# Louietex Manufacturing Ltd. S2L Fashions PVT Ltd

Shondha Sharifpur, National University, Gazipur, Bangladesh  
(+23.967791N, 90.374339E)

24th June 2014

# Observations

Permit drawing elevation - hatched area shows as-built height

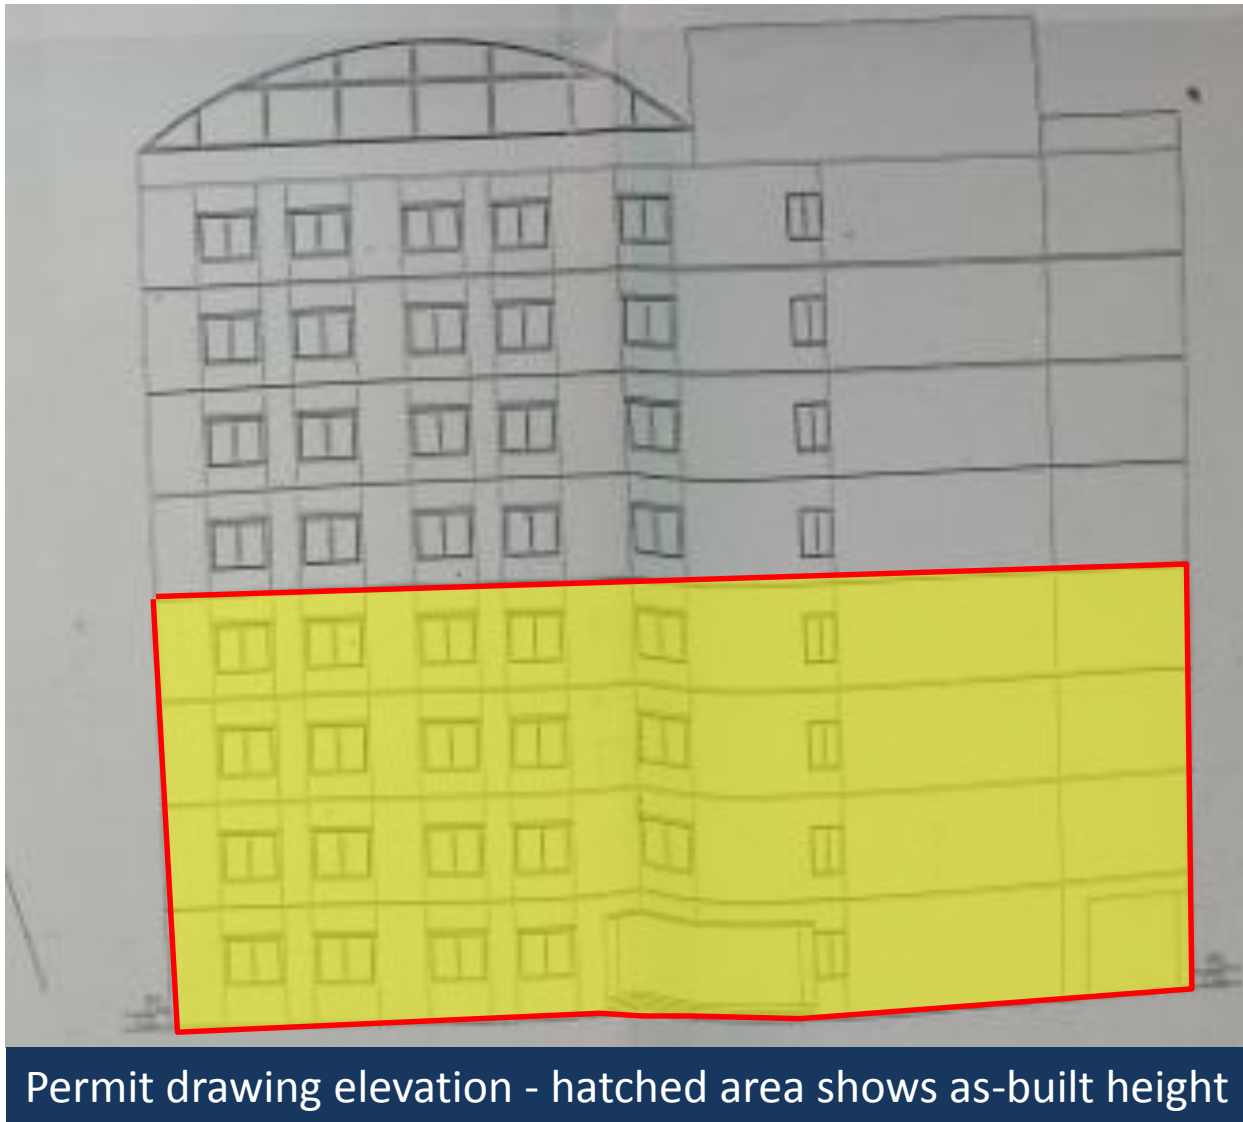
**Future extension likely to result in high column stresses**

During the visit only 4 storeys were constructed but a permit existed for 8 storeys plus a roof shed. If the 8 storeys are constructed the column stresses will need to be reviewed by the Building Engineer.

## Non-engineered structures

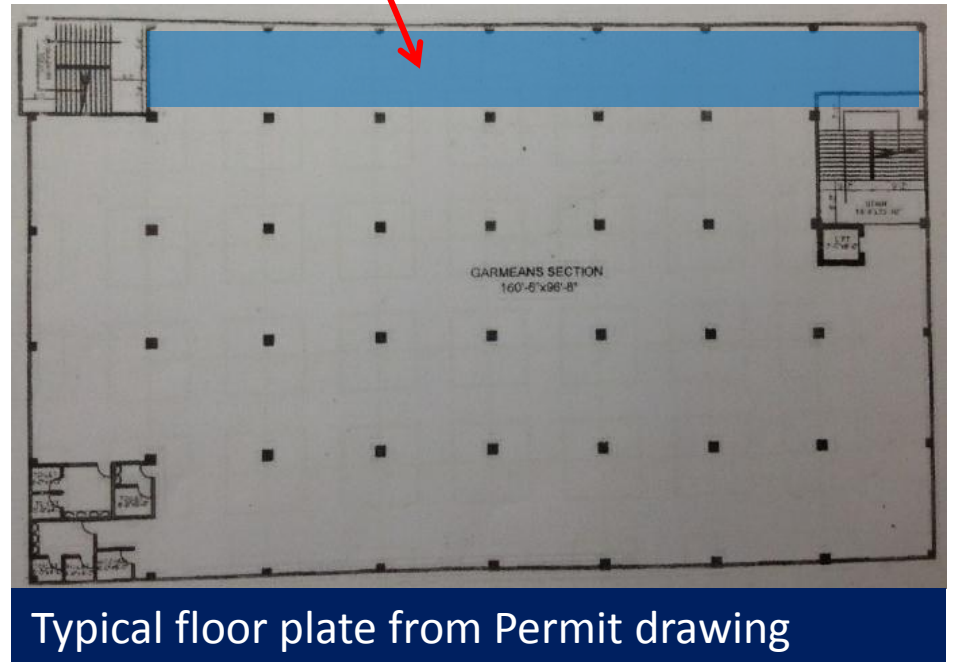
Ancillary buildings and generator room appear to be non-engineered. Structural adequacy of these structures to be assessed for design imposed and wind loads.

Item No.	Observation	Recommended Action Plan	Recommended Timeline
5	Non-engineered structures	Ancillary structures should be designed and upgraded to support code vertical and wind loads by the Building Engineer.	<b>6-months</b>
6	Structural drawings do not match current arrangement of the structure	Building Engineer to commence checking, collecting information and produce accurate and complete as-built documentation.	<b>6-weeks</b>
7	Structural drawings do not match current arrangement of the structure	Complete issue of as-built documentation.	<b>6-months</b>
8	Water damage to masonry façade	Repair/install render and/or waterproofing to ensure prevention of water ingress.	<b>6-weeks</b>
9	Water damage to masonry façade	Inspect structure to ensure no deterioration.	<b>6-weeks</b>

Beam & slab reinforcement drawing

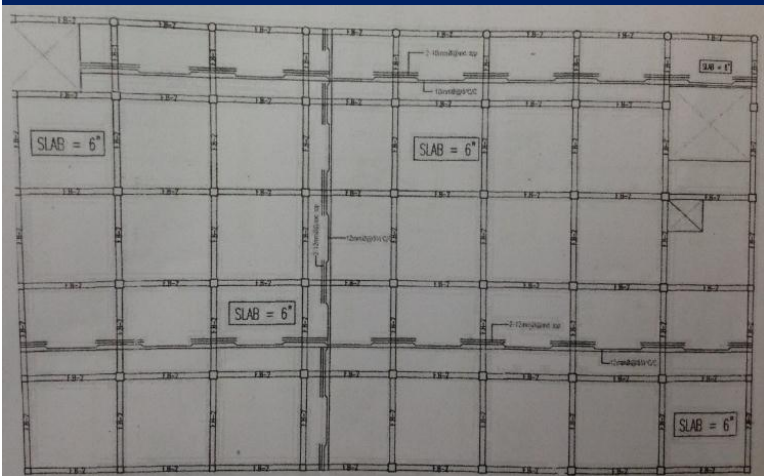
A flat slab was viewed on site. Structural drawings were unclear. We were shown drawings with both downstand beams and flat slabs. Both drawing sets were incomplete.
